From: Stogner, Michael, EMNRD **Sent:** Fri 12/23/2005 2:05 PM
To: Mike Pippin
Cc: Hayden, Steven, EMNRD
Subject: HEC Petroleum's proposed Montoya "25" #4
Attachments:

RE: Answer to Your Requests
Application for Administrative Approval of Unorthodox Location
HEC Petroleum Inc.'s Montoya B 25 #4 Well
2360' FNL and 1165' FWL
Unit E, Section 25, T32N, R13W
San Juan County, New Mexico
Basin Fruitland Coal

Exhibit #2

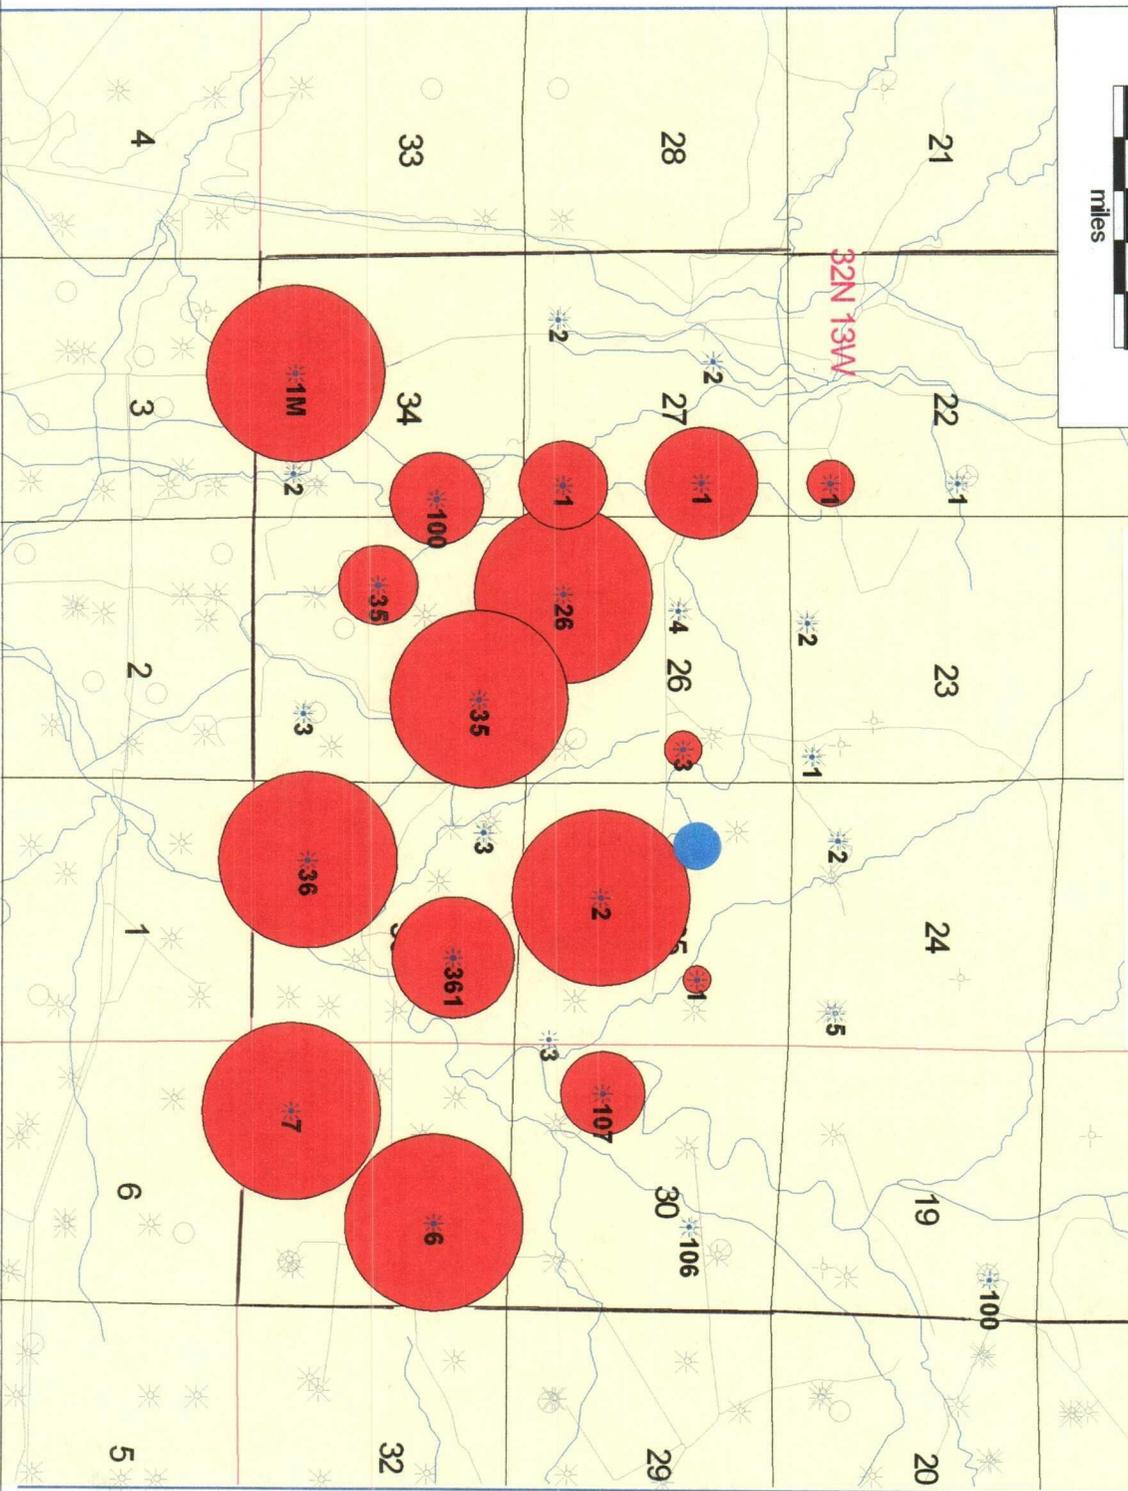
Within the cover letter of your application dated Nov. 28, 2005, you state that "HEC would like to drill this well in the south half of the northwest quarter of Section 25 for geological and drainage reasons." However, there is no discussion or explanation, geologic maps, or other support data attached to the application to valid the necessity for this location. Please supplement your application with a detailed discussion to support your request with the necessary geological maps and drainage calculations.

1. There is gas leak-off or drainage from the outcrop. This can be seen from the attached Cumulative Gas map, (Exhibit #1) of the review area along with the Average Gas Production map, (Exhibit #2) and the Cumulative Gas Contour map, (Exhibit #3). All the better Fruitland Coal wells are further from the outcrop and south of the proposed well. There are at least seven Fruitland Coal wells closer to the outcrop that are all poor gas wells. See the wells in sections 22, 23, & 24 T32N R13W and section 19 T32N R12W.
